Product Change Notification / SYST-13RHMM178

ERRATA - PIC18F06/16Q41 Silicon Errata and Data Sheet Clarifications Revision

PIC18F06/16Q41 Silicon Errata and Data Sheet Clarifications

1.5.1 UART TXDE Signal May go Low Before The STOP Bit Has Been Entirely Transmitted.

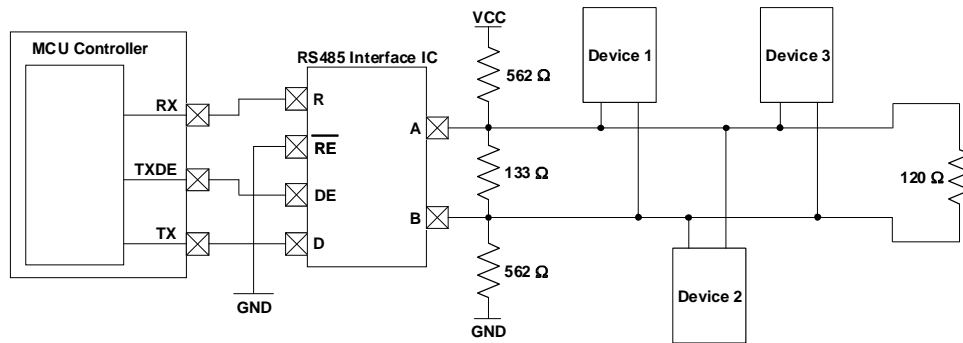
The UART Transmit Drive Enable (TXDE) signal could potentially transition into a low state before the UART STOP bit has been entirely transmitted due to the effects of parasitic capacitance on the TX line. In some applications, this could result in communication being prematurely terminated due to the TXDE bit going low before the STOP bit has had enough time to settle.

In order to ensure that the STOP bit settles into its final logic state before the TXDE signal transitions low, a biasing circuit can be implemented. A biasing circuit allows the TX line to either be driven high or low, rather than being left in a floating tri-state mode where prolonged rise or fall times could lead to communication being disrupted. This bias circuit should only be implemented on one end of the serial bus, and a termination resistor should be used on the other end. The figure below show an example of a bias circuit that can be used to achieve this. Please note that the resistor values used in this circuit are recommendations, and that the actual resistor values required may vary based on the application.
